## **Product/Process Change Notice (PCN)** Major change Minor change **Product Mark** PCN #: PCN AbsSHC 20180514 **Date Code** Product Affected: Packaging Others 36003200S 36103205S PCN Date: February 14th, 2018 Effective Date: May 14th, 2018 Contact: Product Management Attachment: ☐ Yes No Phone: +49 (0) 7942 - 945 5001 Samples: No Fax: +49 (0) 7942 - 945 5179 E-mail: pcn.eisos@we-online.de **DESCRIPTION AND PURPOSE OF CHANGE:** For improved transportation safety, Würth Elektronik eiSos will reduce the reel diameter for WE-SHC 36003200S and WE-SHC 36103205S. **DETAIL OF CHANGE:** Reducing the reel diameter, and consequently the number of parts per reel and the reel weight, the transportation safety of the packaged product will be improved.

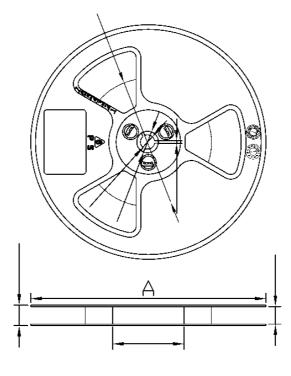
Reel diameter (A) will be reduced from 15" (381mm) to 13" (330mm). All other dimensions will remain unchanged.

Quantities per reel will change as follow:
Before Change: WE-SHC 36003200S: 750 parts per 15" reel WE-SHC 36103205S: 750 parts per 15" reel
After Change: WE-SHC 36003200S: 500 parts per 13" reel WE-SHC 36103205S: 500 parts per 13" reel
RELIABILITY / QUALIFICATION SUMMARY:
Process & Machine approval is according to internal requirements released by the Quality Department and the Product Management Department.
DATA SHEET CHANGE:
